Executive Order G-70-17-B

Relating to the Modification of the Certification of the
Emco Wheaton Balance
Phase II Vapor Recovery System

Emco Wheaton Balance Phase II
Vapor Recovery System

Exhibit 1

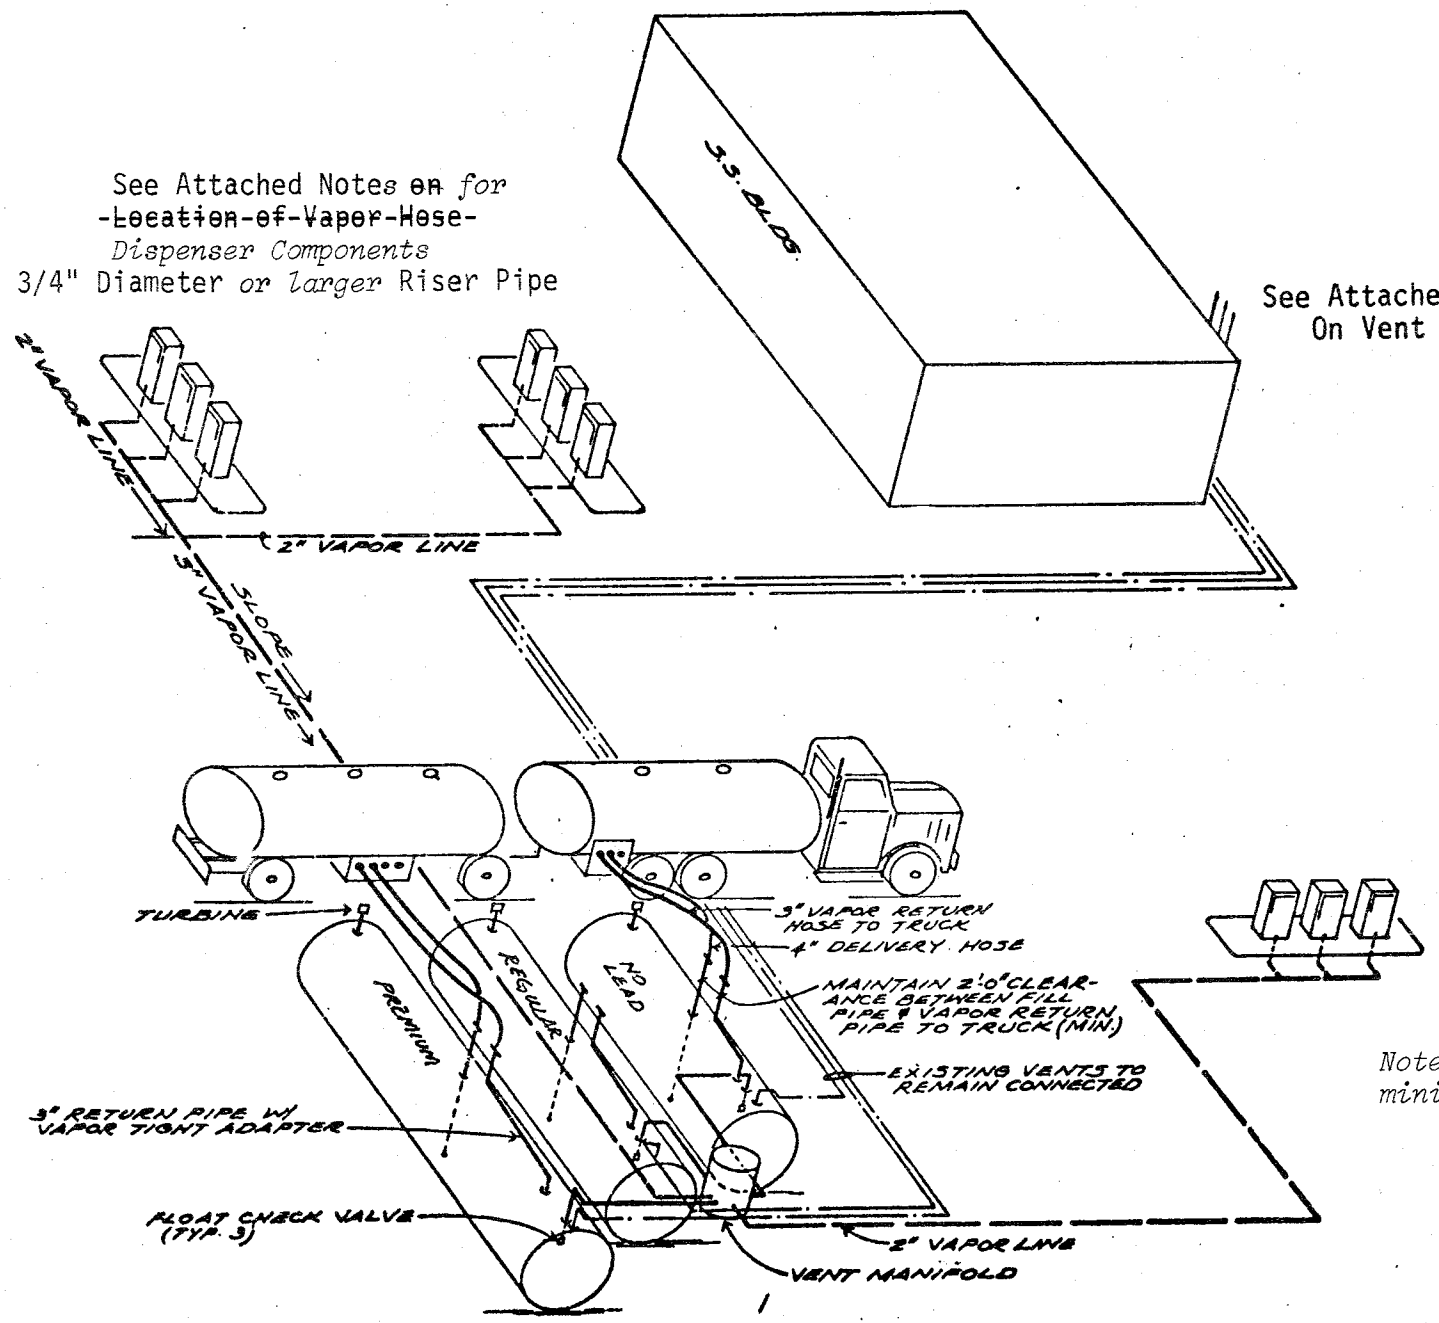
See Attached Notes ~~on~~ *for*
~~Location of Vapor Hose~~
Dispenser Components
3/4" Diameter *or larger* Riser Pipe

See Attached Notes
On Vent Pipes
